Vicinity Property Completion Report

DU-144A S
TRUCK BY-PASS (CAMINO DEL RIO)
DURANGO, COLORADO

RADIOLOGICAL AND ENGINEERING ASSESSMENT (REA)
Review Form

REVIEW COMMENTS

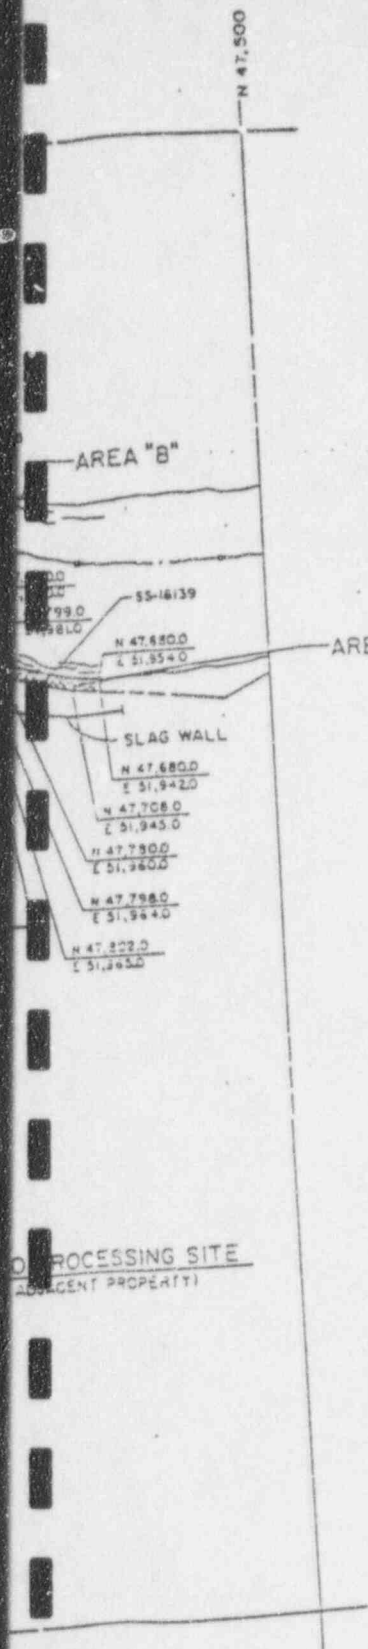
Page 18	TAC	Item 1.1 should state "Z-Pile" not "2-Pile." Item 2.1 should indicate a quantity of 85 cy and Item 2.5 should indicate a quantity of 40 cy (per Drawing DU-144A-015). Item 2.5 should indicate Area B.	Agreed, REA revised.
Appendix C 2786F	TAC	The most recent letter from CDH should be included.	See Appendix C.
